STATE OF HAWAII
DEPARTMENT OF TRANSPORTATION
HIGHWAYS DIVISION
UTILITY PLAN
MAUNA KEA MAINTENANCE
BASEYARD
DANIEL K. INOUE HIGHWAY
Project No. 200A-01-10
Scale: As Shown Date: April, 2018

1	06-07-18	ADDENDUM NO. 4	
REVISION	DATE	DESCRIPTION	AA15

STATE OF HAWAII
DEPARTMENT OF TRANSPORTATION
HIGHWAYS DIVISION
SHOP BUILDING
MAUNA KEA MAINTENANCE BASEYARD
DANIEL K. INOUE HIGHWAY
Project No. 200A-01-10

EAST EXTERIOR ELEVATION
SCALE: 3/16" = 1'-0"

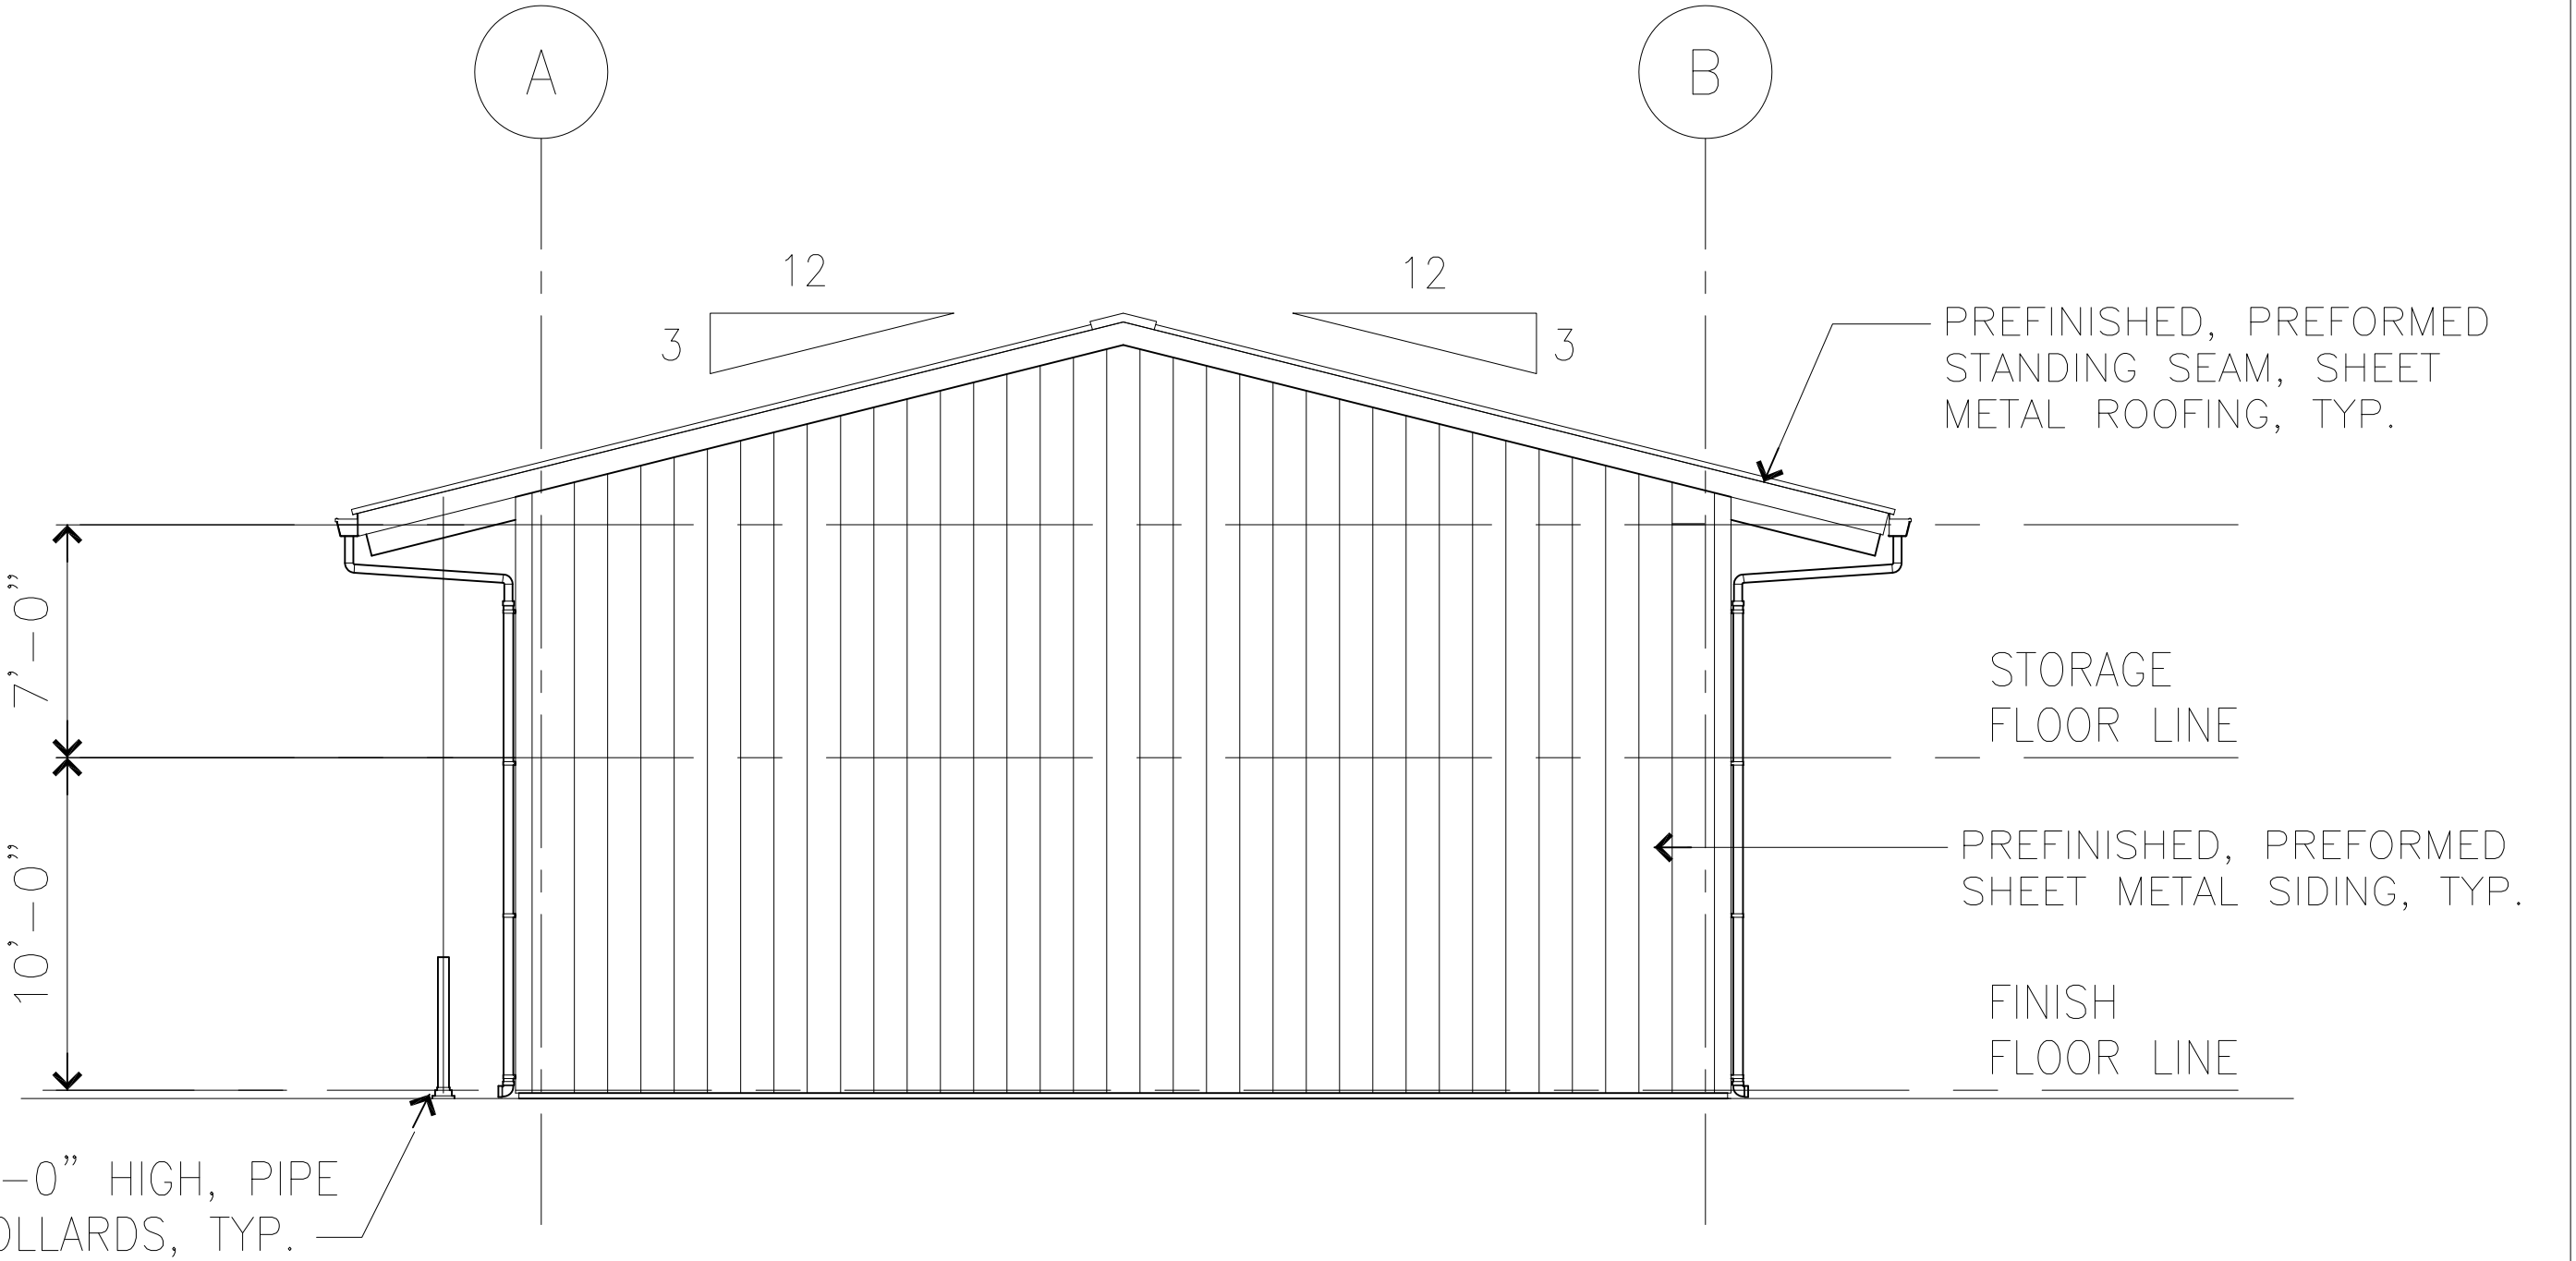
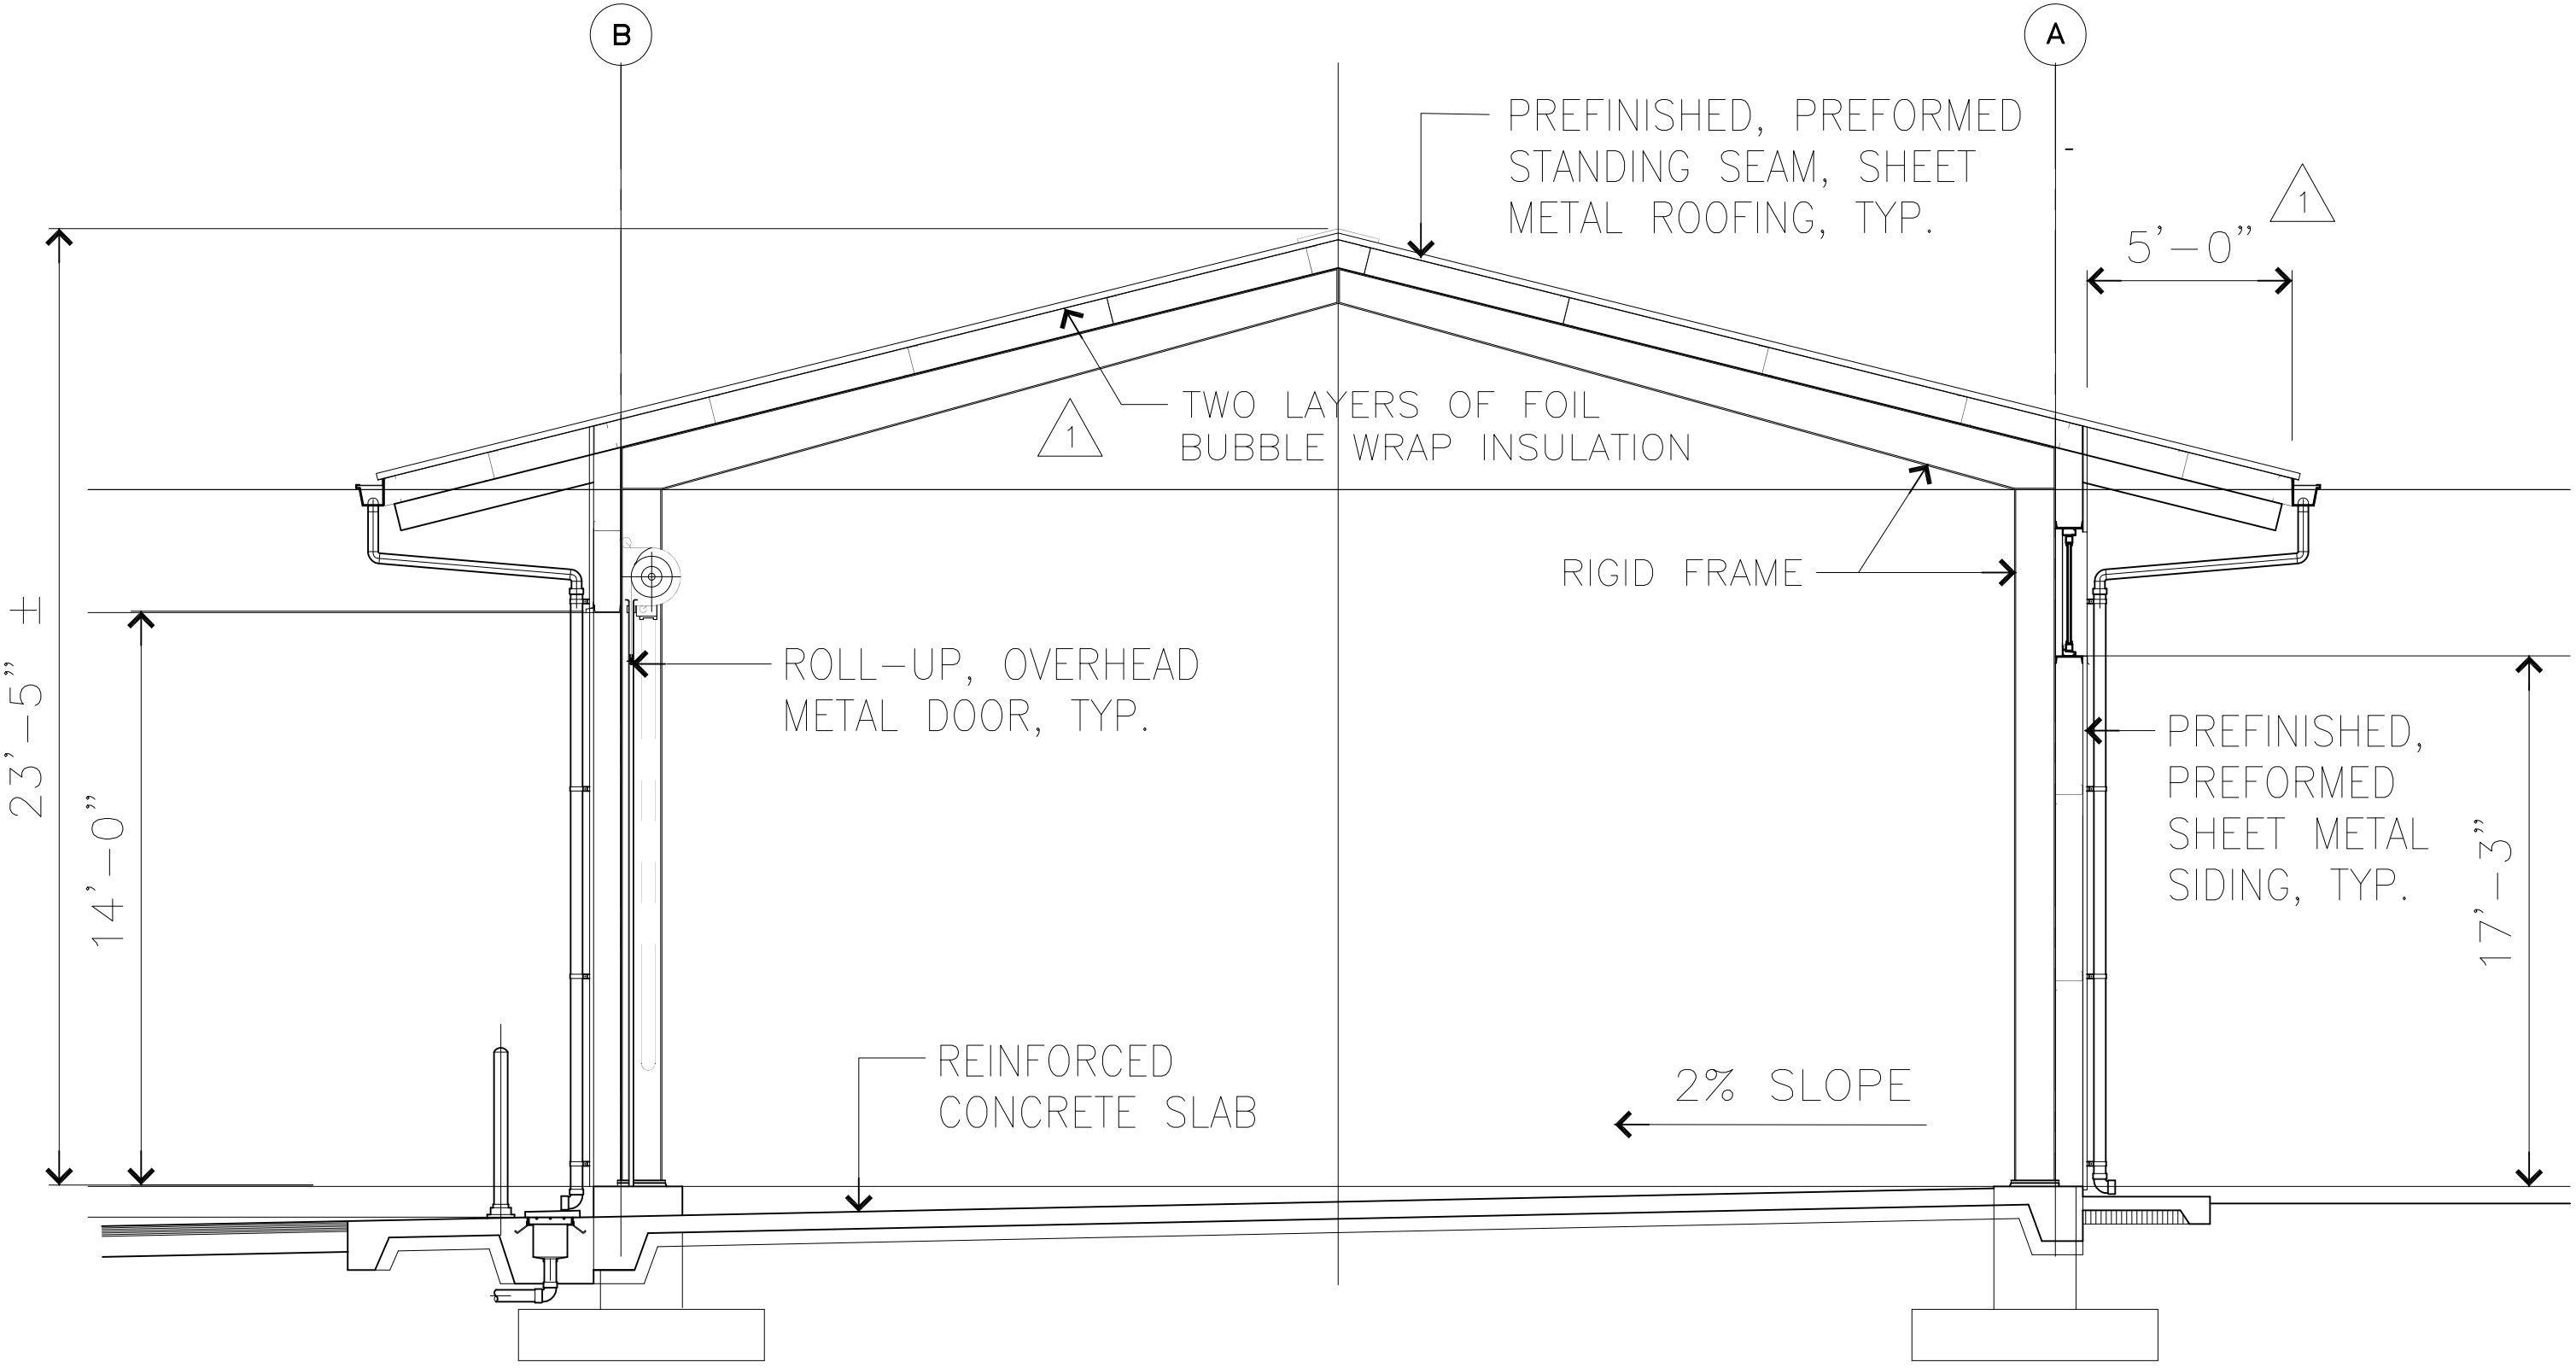
06-07-18	1	REVISED DIMENSION AND INSULATION LOCATION
DATE	REVISION
